Subject: AP1000 Responses to Requests for Additional Information (SRP3.10)

Responses to Requests for Additional Information on SRP Section 3.10

AP1000 TECHNICAL REPORT REVIEW

Figure 1

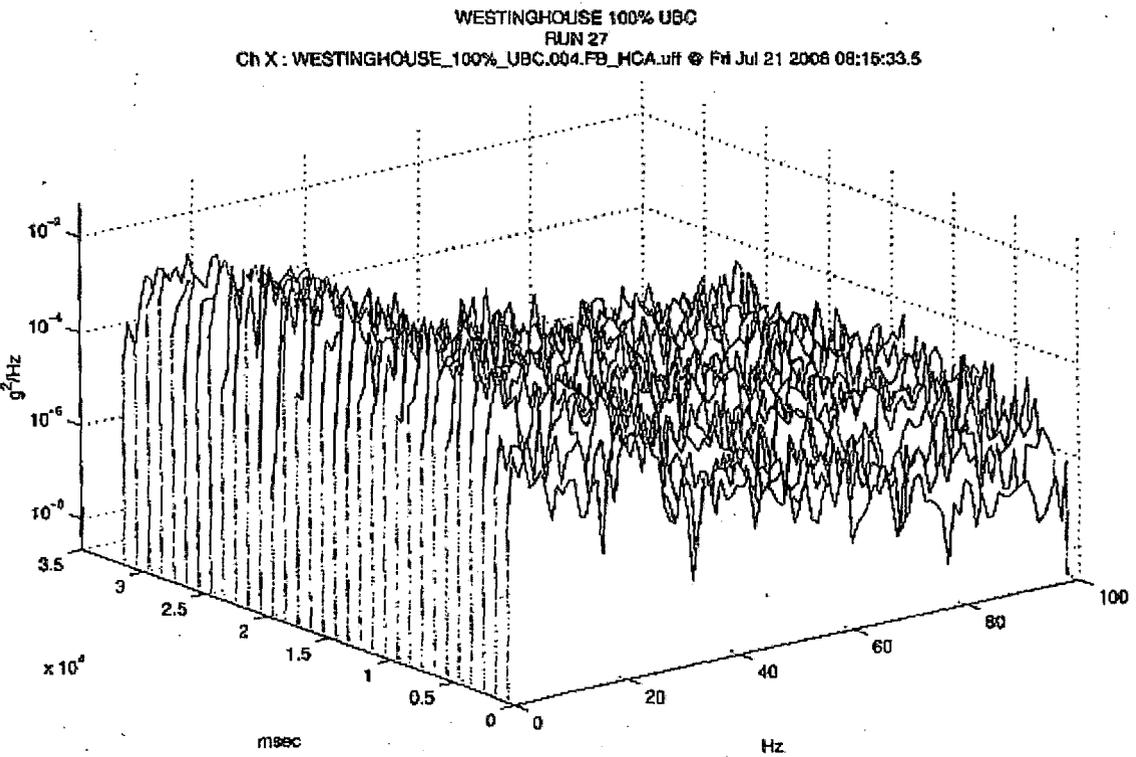
What are the justifications for the conclusion addressing use of existing test data in Sections 6.4.1 and 6.4.7 (Summary and Conclusion)? Most of the existing qualification test data were obtained using frequency inputs to the shake table up to 33 Hz. The test response acceleration of 2.0g (zero period acceleration at 5 percent critical damping) shown in the existing test data obtained from the low frequency (less than 33 Hz) seismic tests may not represent the actual response acceleration of the electrical/electronic equipment/components with natural frequencies higher than 33 Hz, when the RRS contains the required frequency input higher than 33 Hz. In order for the existing data to be valid for resolving HF concerns, the adequacy of the time history or the adequacy of the frequency contents and the stationarity of the frequency contents of the synthesized waveform used for the shake table tests must be shown to be compatible with the amplified region of the RRS at high frequencies. IEEE 344-1987 requirements must be met.

Figures 1 through 6 provide examples of test data which demonstrate frequency content in the 25 Hz to 50 Hz range.
